Access Compliance Report
Public Rights-of-Way
(Curb Ramps)

Intersection ID: 11480	**Main Street:** N_CEDAR_ST	**Cross Street:** W_5TH_ST	**Location:** W
ADA ID: DE5C06C2CE80	**Ramp Type:** PerpDiag	**Initial Pass/Fail:** Fail	**Overall Compliance:** No **Severity Score:** 13.75

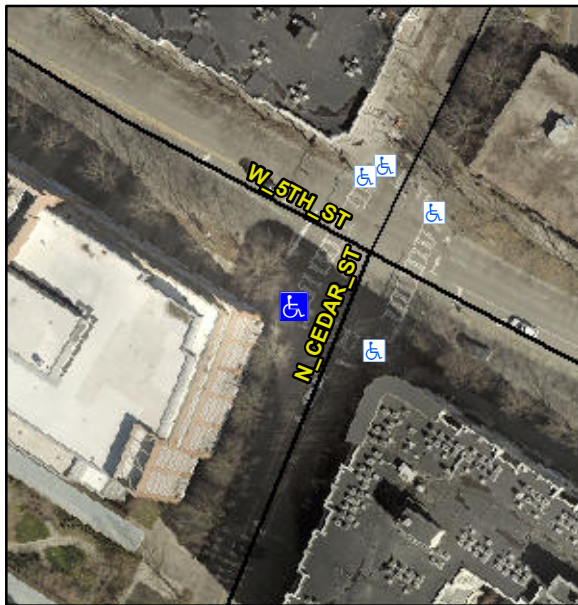
R304.2.2, R304.5.3

Compliance	Description	Data	Compliance	Description	Data
N/A	Ramp Length (in)	84.0	No	Ramp Slope (%)	10.0
Yes	Ramp Width (in)	48.0	No	Ramp XSlope (%)	3.0
N/A	Flare Type LT	N/A	N/A	Flare Type RT	N/A
N/A	Flare Slope LT (%)	N/A	N/A	Flare Slope RT (%)	N/A
N/A	Flare Traversable LT?	N/A	N/A	Flare Traversable RT?	N/A
N/A	Landing Length (in)	N/A	N/A	DWS Provided?	N/A
N/A	Landing Width (in)	N/A	N/A	DWS Contrast?	N/A
N/A	Landing Slope (%)	N/A	N/A	DWS Length (in)	N/A
N/A	Landing X Slope (%)	N/A	N/A	DWS Full Width?	N/A
N/A	Landing Curb? (Y/N)	N/A	N/A	DWS Offset (in)	N/A
N/A	Shared Landing?	N/A			
N/A	Gutter Ponding?	N/A	N/A	Gutter Slope (%)	N/A
N/A	Gutter Lip Ht (in)	N/A	N/A	Gutter X Slope (%)	N/A
N/A	Painted X Walk1?	Yes	N/A	Painted X Walk2?	Yes
	X Walk 1 Direction	To SE		X Walk 2 Direction	To NE
N/A	X Walk 1 Width (in)	106.0	N/A	X Walk 2 Width (in)	105.0
	X Walk 1 Slope (%)	5.3		X Walk 2 Slope (%)	3.1
	X Walk 1 X Slope (%)	1.6		X Walk 2 X Slope (%)	1.8

Remove & Replace Curb Ramp With Two New Directional Ramps or Equivalent.
